**SUSQUEHANNA STEAM ELECTRIC STATION  
PROPOSED AMENDMENT TO LICENSES NPF-14  
AND NPF-22: REVISION TO THE DOSE  
CONSEQUENCE ANALYSIS FOR A LOSS OF  
COOLANT ACCIDENT  
PLA-7823**

**Docket No. 50-387  
and 50-388**

# **Enclosure 1 to PLA-7823**

## **Description and Assessment**

**Figure 1: Release Paths for Susquehanna DBA LOCA**

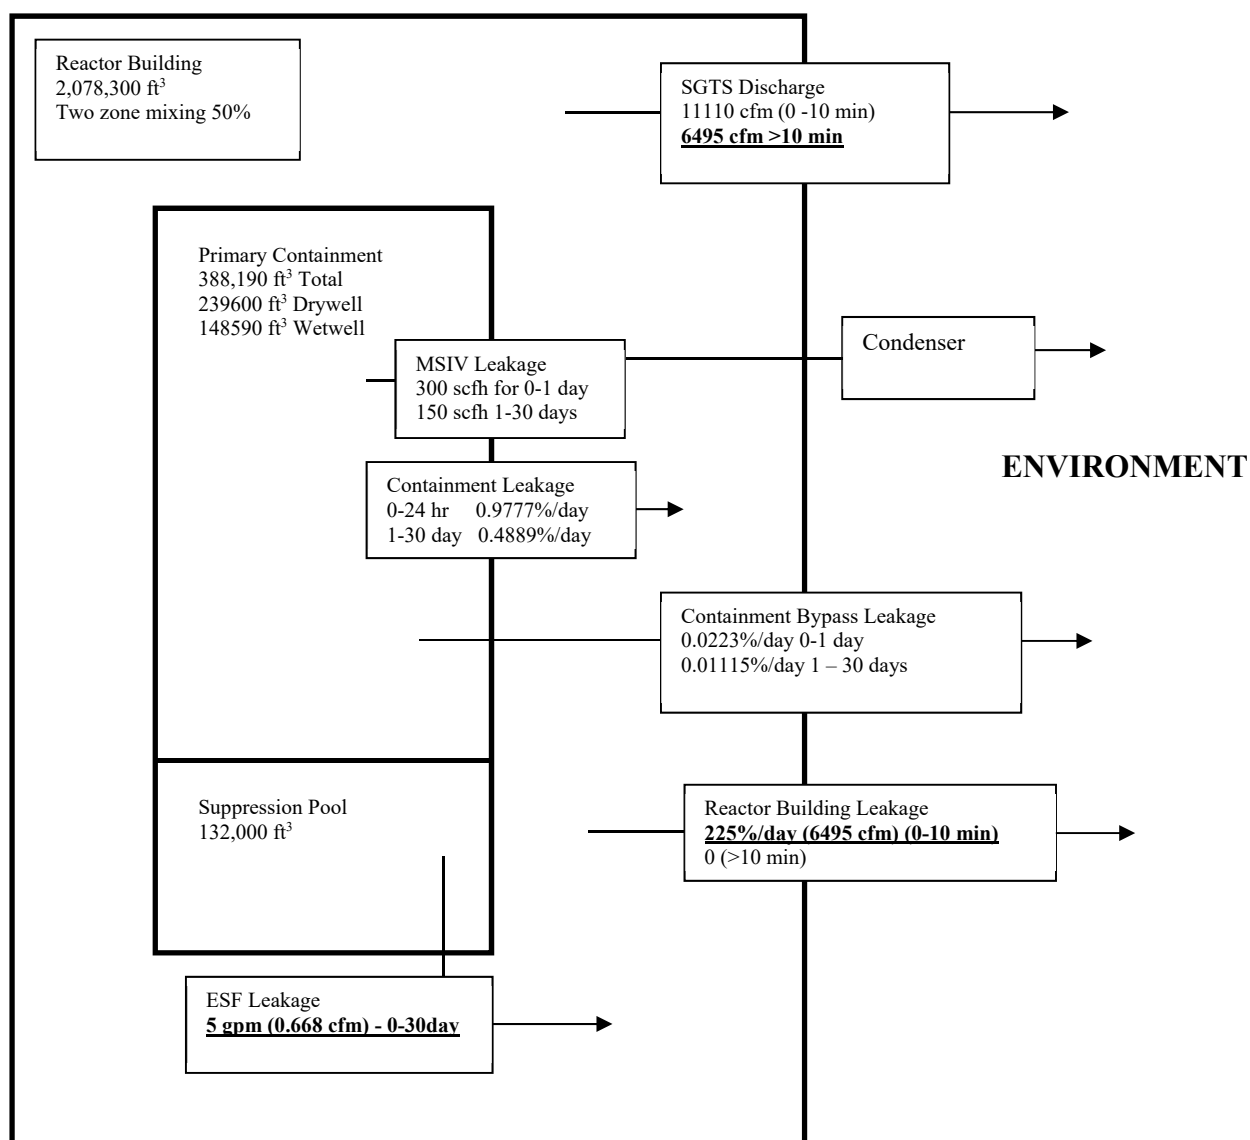
Amendment 251/231 (Reference 3). Figure 1 provides a graphical representation of the release paths for the DBA LOCA and shows the relevant proposed changes; the changes are shown in bold and underlined. Enclosure 2 provides a summary table of the inputs and assumptions used in the Susquehanna DBA LOCA analysis.
